COUNCIL RESOLUTION NO. 2005-183

A RESOLUTION OF THE COUNCIL OF THE CITY OF FRESNO, CALIFORNIA, CERTIFYING ENVIRONMENTAL IMPACT REPORT NO. 10133 (STATE CLEARINGHOUSE NO. 2004021071) AS RELATED TO THE PROPOSED FANCHER CREEK PROJECT

2025 Fresno General Plan
Transportation Element
(Streets and Highways)

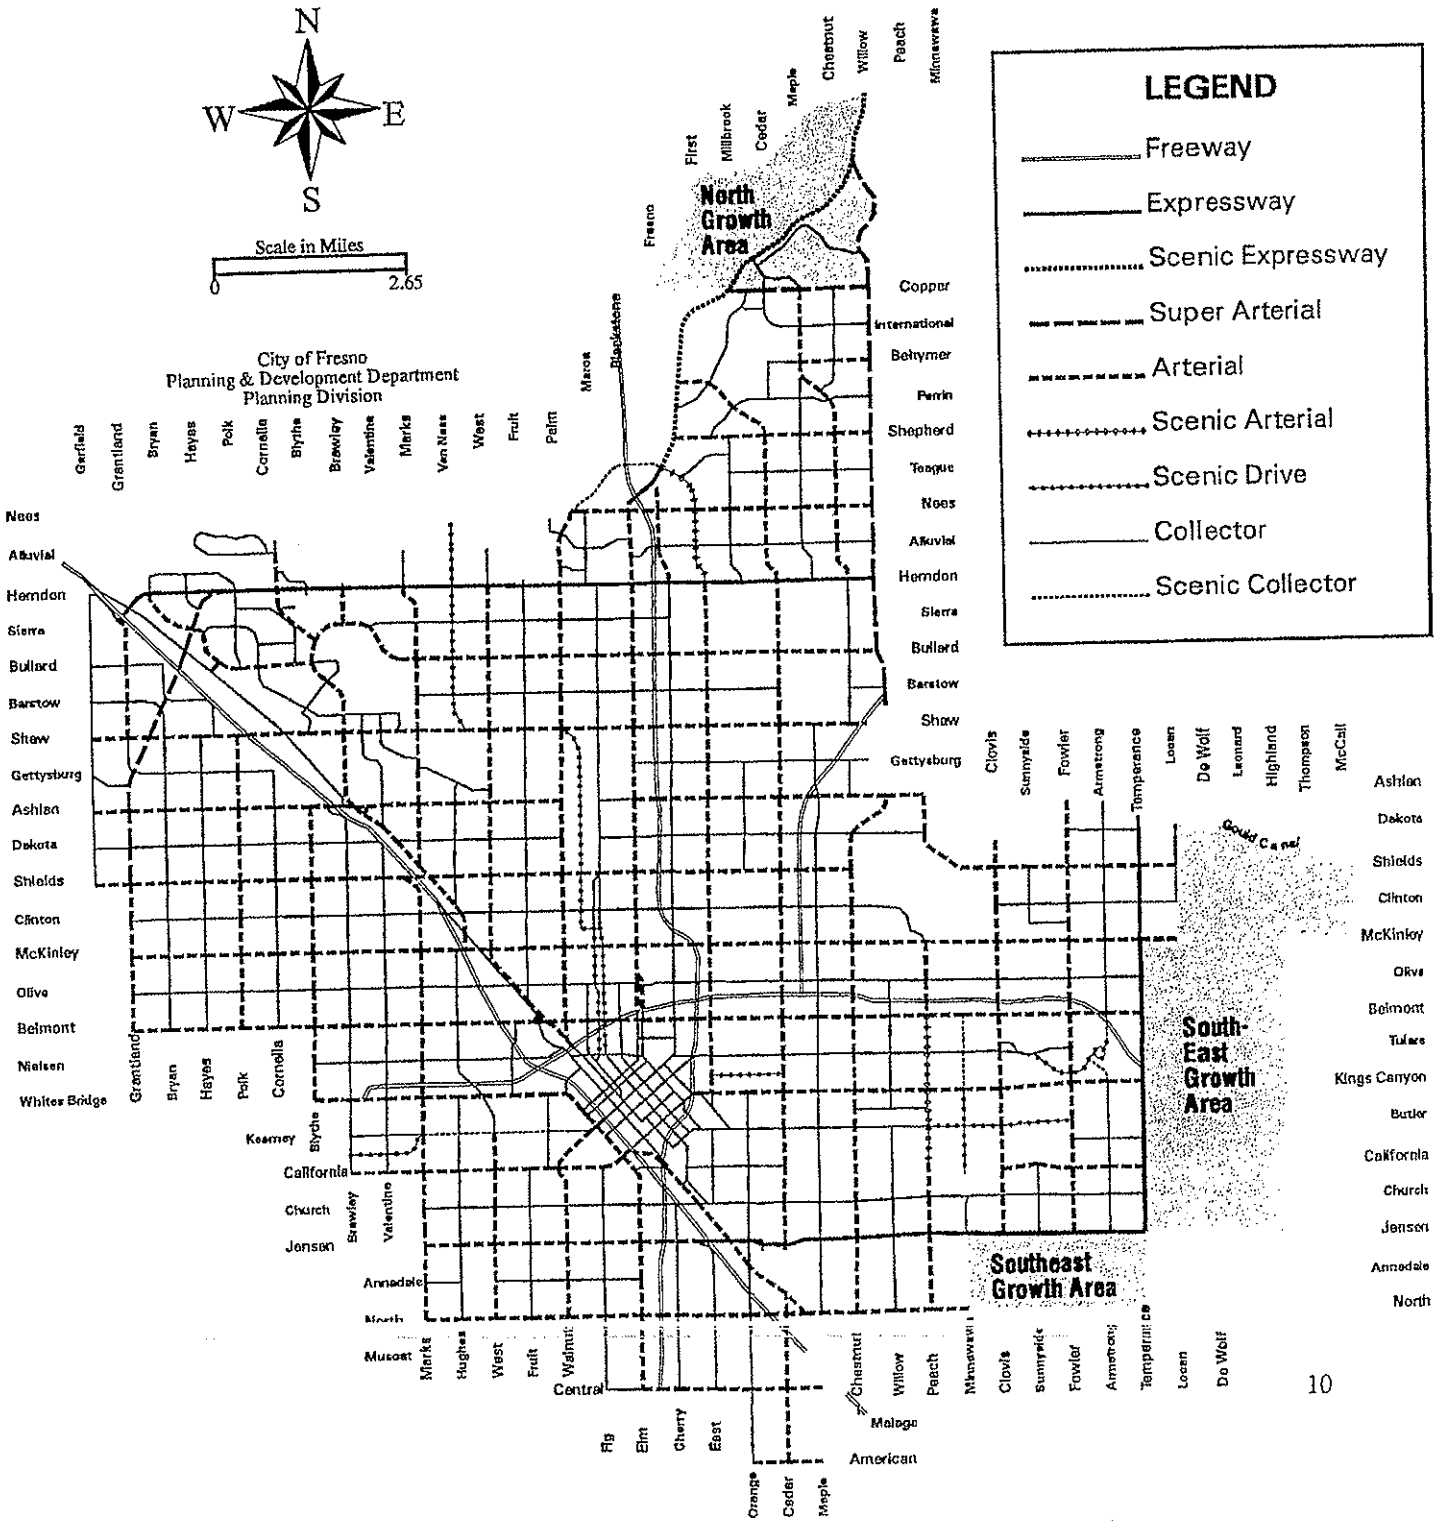
The MEGG parcel is, in fact, an integral part of the Project under review, as the Project will require the construction of transportation infrastructure necessary to the Project on the MEGG parcel. Figure 2.2-1 (DEIR page 2.2.14) shows that the proposed circulation system in the vicinity of the Project includes:

The circulation configuration shown in Figure 2.2.14 is consistent with the adopted circulation system. Tulare Street was designated as a collector street extending east from the current "T" intersection at Clovis Avenue on the 1984 Fresno General Plan and the 1992 Roosevelt Community Plan. This designation was carried forth on the 2025 Fresno General Plan. A collector is defined by the Circulation Element of the General Plan as a, "Two-to- four lane undivided roadway, with the primary function of connecting local streets and arterials and neighborhood traffic generators and providing access to abutting properties."

Figure 1-2: Specific Location, Project Areas, Proposed Zoning

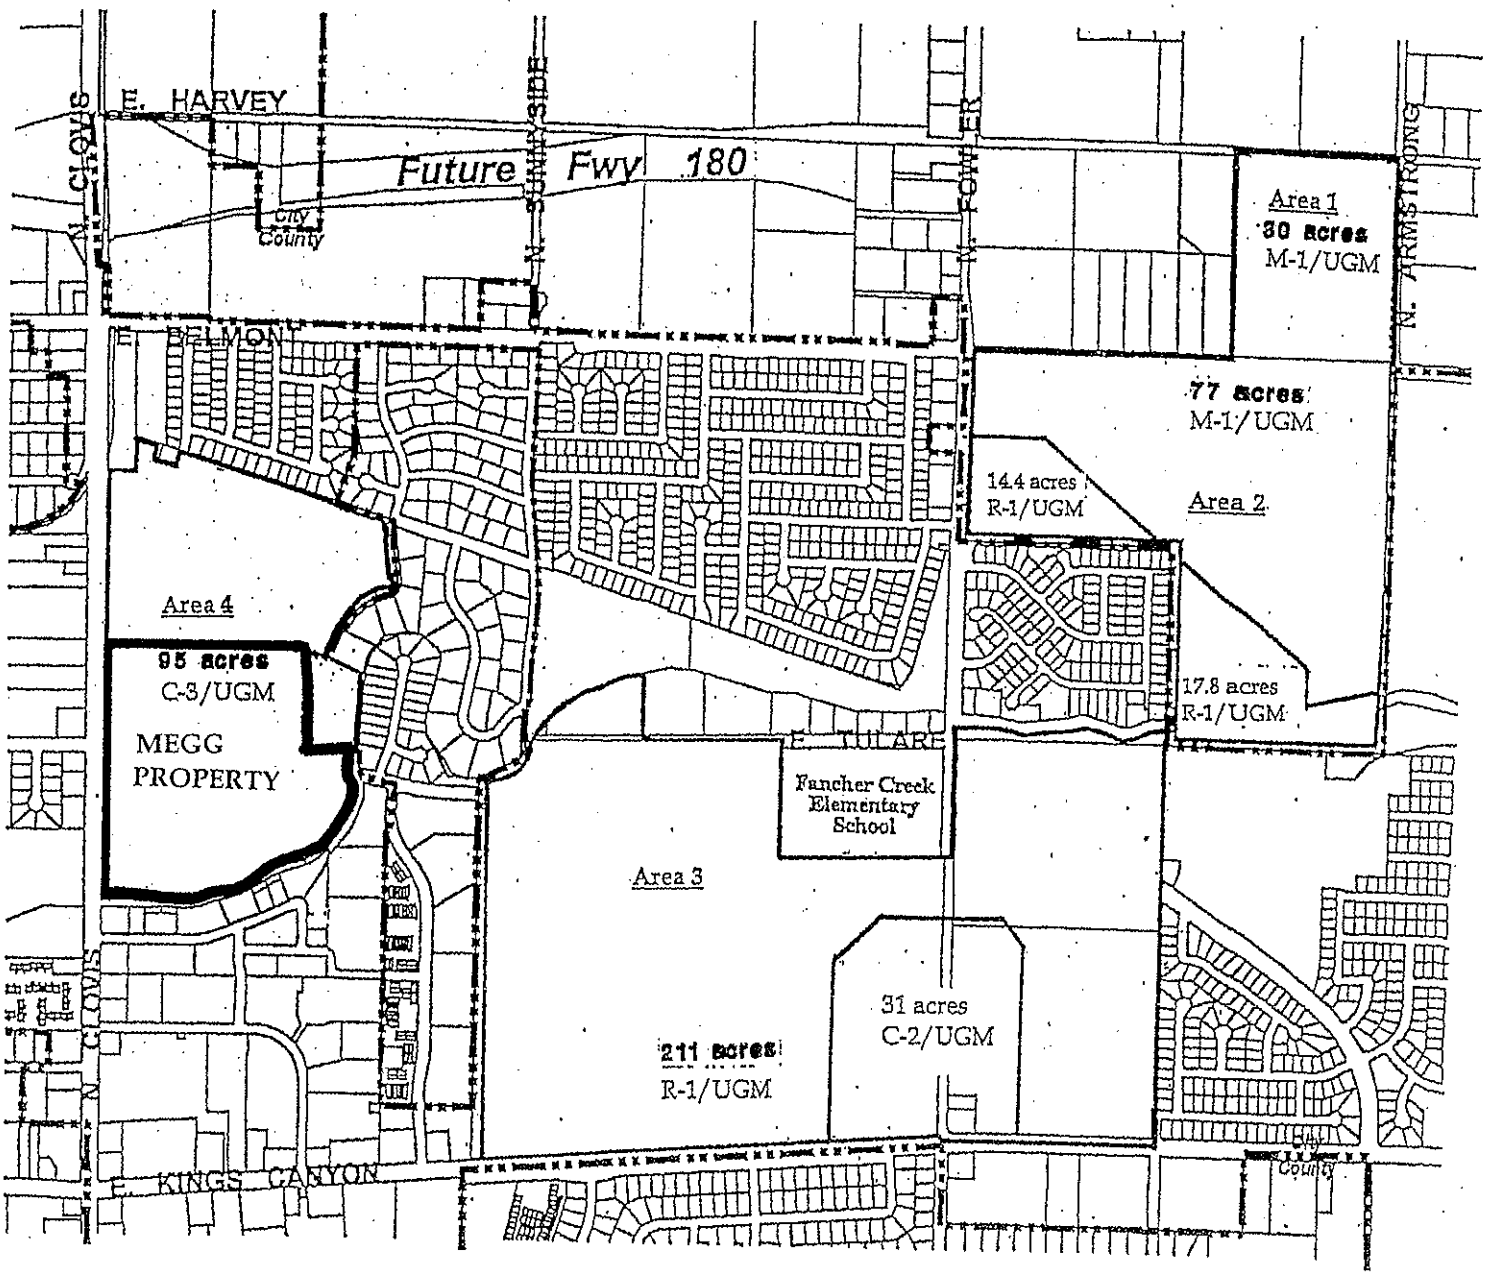
The MEGG parcel is not integral to the development of the balance of the project but it is integral to implementation of the General Plan circulation system. The project description and maps clearly show the planned public circulation system as adopted by the City of Fresno. Because development of the balance of the project does not require the MEGG parcel, the project description is considered adequate for purposes of describing the planned circulation system in the project area. Figure 1-2 is revised to show the boundaries of the MEGG property.

Figure 1-2 revised

Figure 5: Distribution of Nitrate in Well Water (200-04)

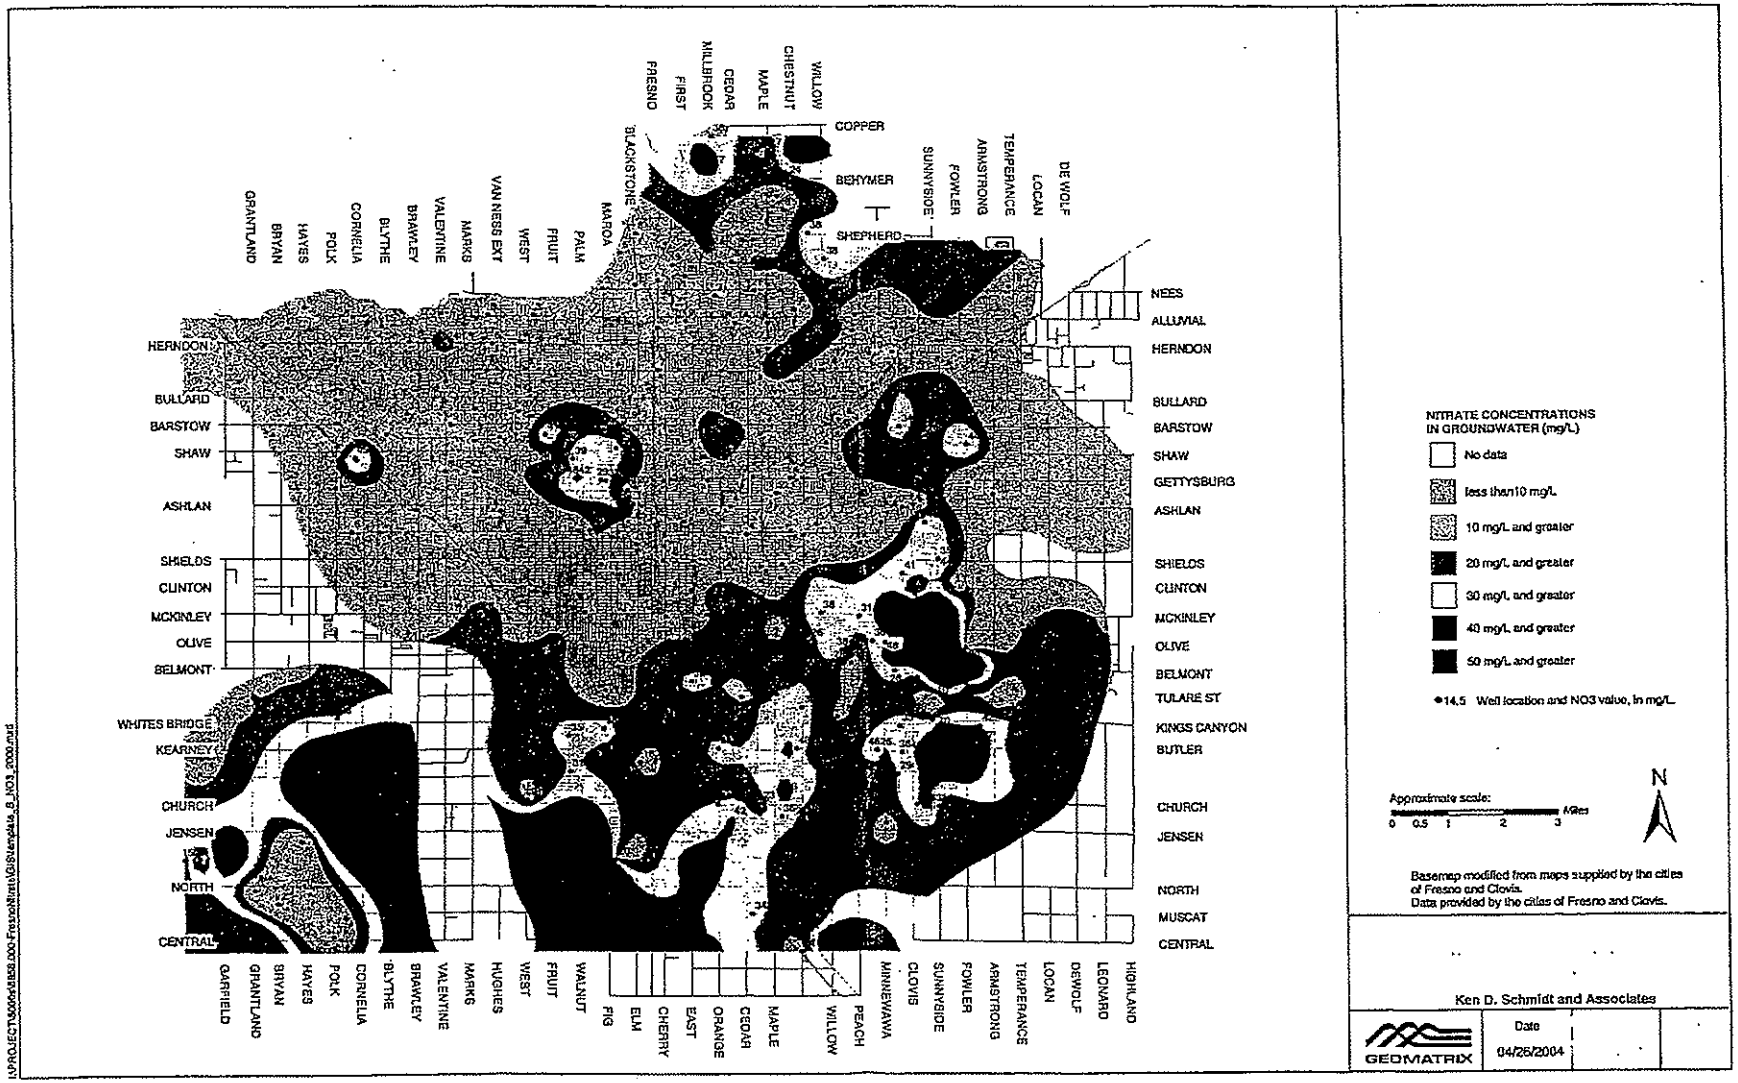
18. Figure 5 in the DEIR, identifies areas of high nitrate concentrations in the project vicinity, in particular north of the project. Such contaminant concentrations should be taken into consideration when siting recharge facilities.
